ACCESS DESIGN REVIEW – STATE SIGNIFICANT DEVELOPMENT APPLICATION (SSDA)

Douglas Park Memorial Park – Stage 1

Project Number: 01146

Report Type: Access Design Review – State Significant Development Application (SSDA)

Figure 3 – Chapel Floor Plan
Source: Design Cubicle

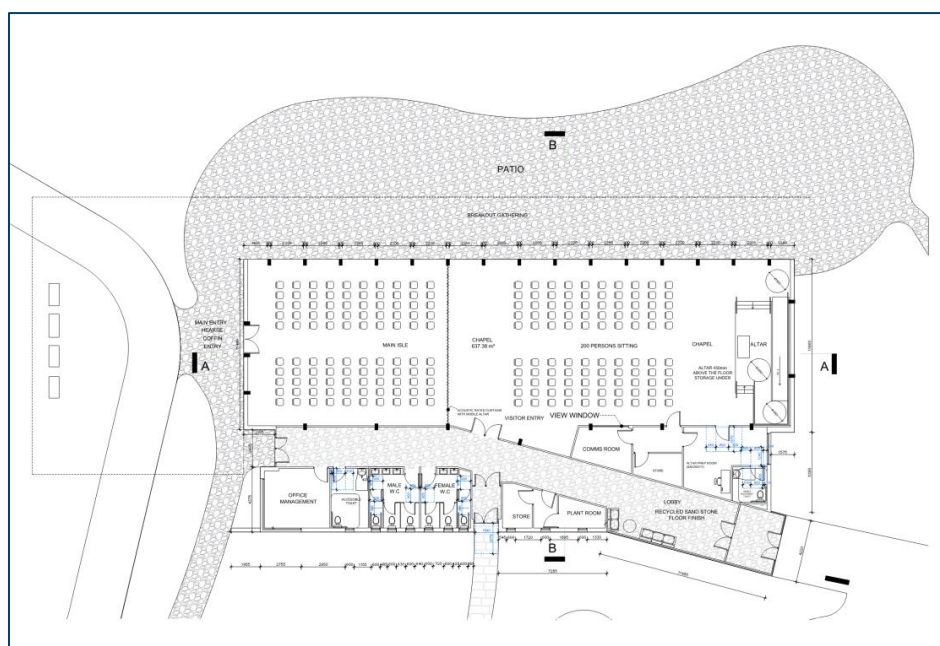
The chapel building is also single-storey but incorporates a level change at the altar, with two stairways providing access from either side and a 1:14 ramp accessing it from the rear. Both the stairs and ramp provide the required minimum 1000mm path of travel and include handrails on both sides. The ramp also incorporates sufficient 180° turning space at the landing. Therefore, they appear capable of achieving compliance with accessibility requirements. Detailed provisions for TGSIs, handrails, kerb rails, and stair tread nosings will be assessed during design development and construction documentation stages.

All rooms and corridors required to be accessible have been designed with sufficient space to allow a wheelchair user to perform both 90° and 180° turns where needed. Additionally, the altar area in the chapel also appears to provide this required turning space. Generally, rooms and corridors have been generously sized to provide ample passing spaces and facilitate easy counterflow of people moving throughout the building, in line with best practice universal design principles.

Figure 4 – Administration Building Floor Plan
Source: Design Cubicle

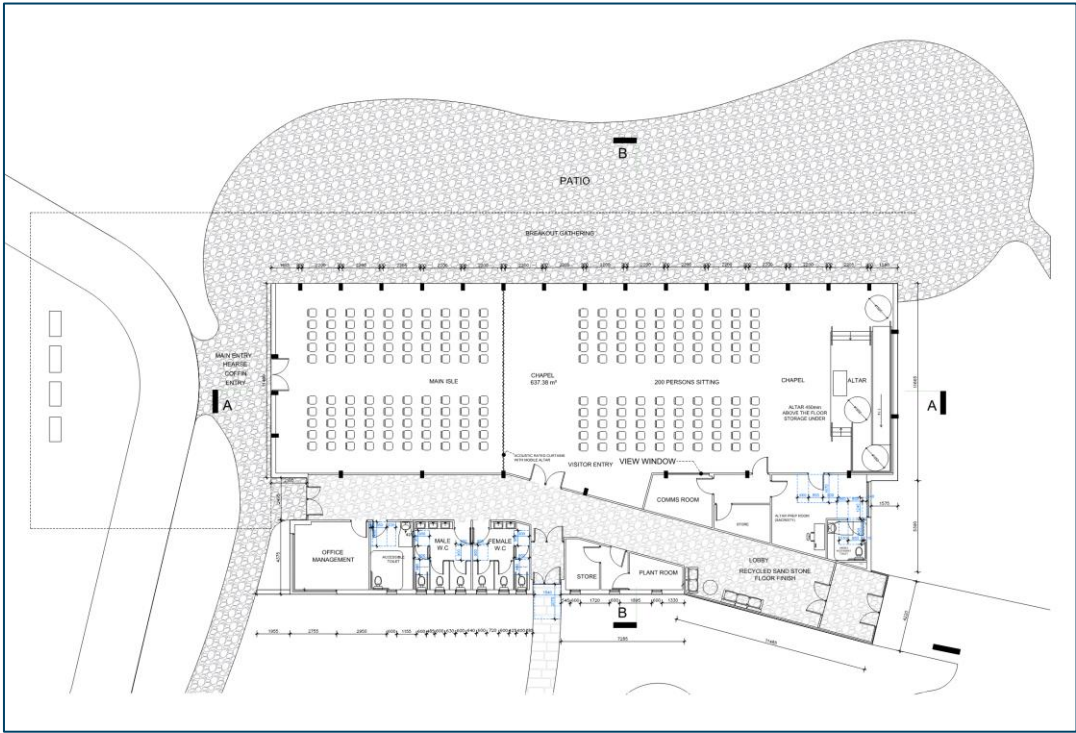
The administration building contains two (2) banks of sanitary facilities. The sanitary facilities associated with the café/flower shop are accessed via an external building entrance and include male and female ambulant toilets, as well as an accessible toilet (RH). The internal bank of sanitary facilities is split, with the male and female facilities containing requisite ambulant toilets located in the south wing of the building, and the accessible sanitary facility (LH) located in the north wing. While this layout complies with accessibility requirements, we note that the north wing may be a secure staff area. Therefore, consideration should be given to public access to this accessible facility in future design development, as it would not be equitable to require a visitor to use the external sanitary facilities when internal facilities are provided.

All building entrances are currently detailed as fully accessible and, therefore, do not require directional signage. However, within the administration building, directional signage will be necessary at the south wing bank of internal sanitary facilities to indicate the direction to the accessible toilet in the north wing.

Figure 5 Storage Shed/ Garage Floor Plan
Source: Design Cubicle

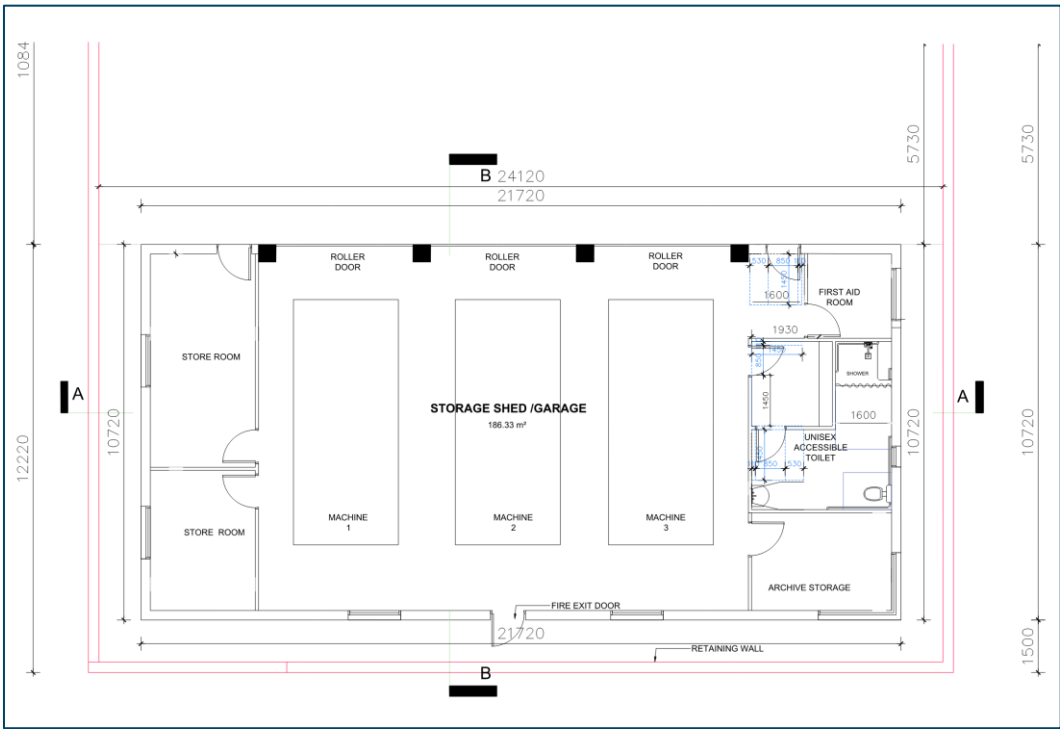
The Storage Shed/ Garage building includes two (2) car parking spaces. There are no requirements for the provision of accessible parking bays for a Class 10 building.

In the Storage Shed/ Garage building, one accessible toilet (LH) and shower are provided, accessed via an airlock from the machine workspace. Within the chapel building, an accessible toilet (RH) is located in the sacristy, and a public accessible toilet (LH) is provided off the main hallway. Additionally, male and female ambulant toilets are included in this bank of sanitary facilities off the main hallway.
